# UNITED STATES PATENT AND TRADEMARK OFFICE

APPLICATION NO.	FILING DATE	FIRST NAMED INVENTOR	ATTORNEY DOCKET NO.	CONFIRMATION NO.
10/718,514	11/24/2003	Kenneth Gordon Walker	W245 0004	1974
720	7590	08/15/2006	EXAMINER	
OYEN, WIGGS, GREEN & MUTALA LLP			BOGART, MICHAEL G	
480 - THE STATION			ART UNIT	PAPER NUMBER
601 WEST CORDOVA STREET				
VANCOUVER, BC V6B 1G1			3761	
CANADA

<b>Office Action Summary</b>	Application No.	Applicant(s)	
	10/718,514	WALKER, KENNETH GORDON	
	Examiner Michael G. Bogart	Art Unit 3761

## **DETAILED ACTION**

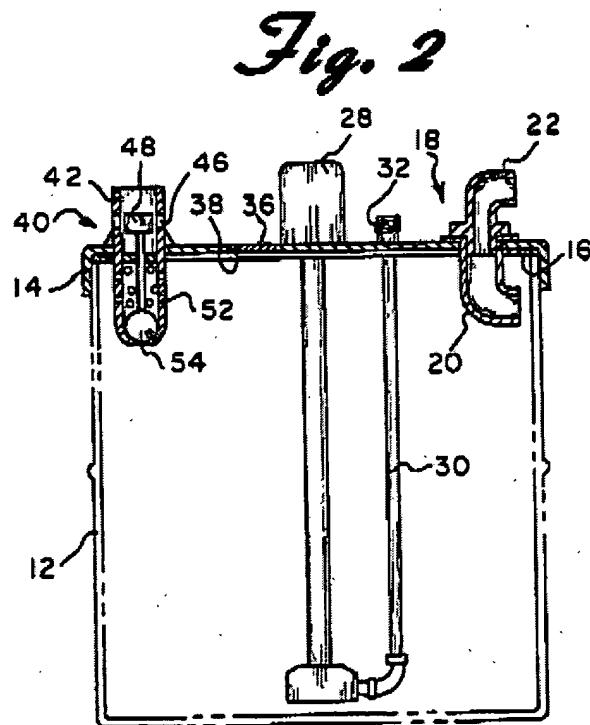
Claim 3 is rejected under 35 U.S.C. § 102(b) as being anticipated by Hallsworth *et al.* (US 4,246,676; hereinafter “Hallsworth”).

Hallsworth teaches a check valve (48) for a canister (12) adapted to receive fluids, said canister (12) having a vacuum port (40) for application of vacuum to said canister (12) for inducing a flow of fluids into said canister (12), said check valve (48) being operably coupled to said vacuum port (40) for stopping said application of vacuum to said canister (12) when said fluids in said canister (12) reach a pre-determined level upper, said check valve (48) comprising:

(a) a floatball (54) operatively coupled to a needle valve (56, 48); said floatball being positioned below said needle valve (56, 48) to lift said needle valve upwardly to effectively stop the vacuum applied to the vacuum port when said fluids reach said upper level; and

(b) a needle valve (56, 48);  
(c) a floatball cage (50) for housing said floatball (54), said floatball cage comprising a needle valve guide (62) for slidably retaining said needle valve (56, 48)(col. 3, lines 22-64)(see figure 2, infra).
